Access Compliance Report

Public Rights-of-Way

Intersection ID: 45786	Main Street: LONG_HILL_DR	Cross Street: SHELLVIEW_LN	Location: W
ADA ID: B0CAB3C35898	Ramp Type: PerpDiag	Initial Pass/Fail: Fail	Overall Compliance: No
Severity Score: 8.75			
Codes/Mitigation Info/Possible Solution		Field Measurements/Component Compliance

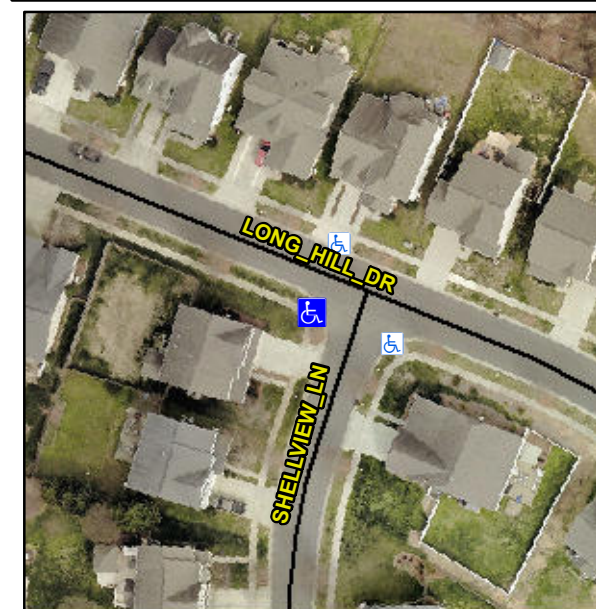
Not Found, R304.5.1

Compliance	Description	Data	Compliance	Description	Data
N/A	Ramp Length (in)	73.0	Yes	Ramp Slope (%)	5.3
No	Ramp Width (in)	47.5	Yes	Ramp XSlope (%)	0.6
N/A	Flare Type LT	N/A	N/A	Flare Type RT	N/A
N/A	Flare Slope LT (%)	N/A	N/A	Flare Slope RT (%)	N/A
N/A	Flare Traversable LT?	N/A	N/A	Flare Traversable RT?	N/A
N/A	Landing Length (in)	N/A	N/A	DWS Provided?	N/A
N/A	Landing Width (in)	N/A	N/A	DWS Contrast?	N/A
N/A	Landing Slope (%)	N/A	N/A	DWS Length (in)	N/A
N/A	Landing X Slope (%)	N/A	N/A	DWS Full Width?	N/A
N/A	Landing Curb? (Y/N)	N/A	N/A	DWS Offset (in)	N/A
N/A	Shared Landing?	N/A			
N/A	Gutter Ponding?	N/A	N/A	Gutter Slope (%)	N/A
N/A	Gutter Lip Ht (in)	N/A	N/A	Gutter X Slope (%)	N/A
N/A	Painted X Walk1?	No	N/A	Painted X Walk2?	No
	X Walk 1 Direction	To SE		X Walk 2 Direction	To NE
N/A	X Walk 1 Width (in)	N/A	N/A	X Walk 2 Width (in)	N/A
	X Walk 1 Slope (%)	1.9		X Walk 2 Slope (%)	1.9
	X Walk 1 X Slope (%)	0.2		X Walk 2 X Slope (%)	2.2

Remove & Replace Curb Ramp With Two New Directional Ramps or Equivalent.
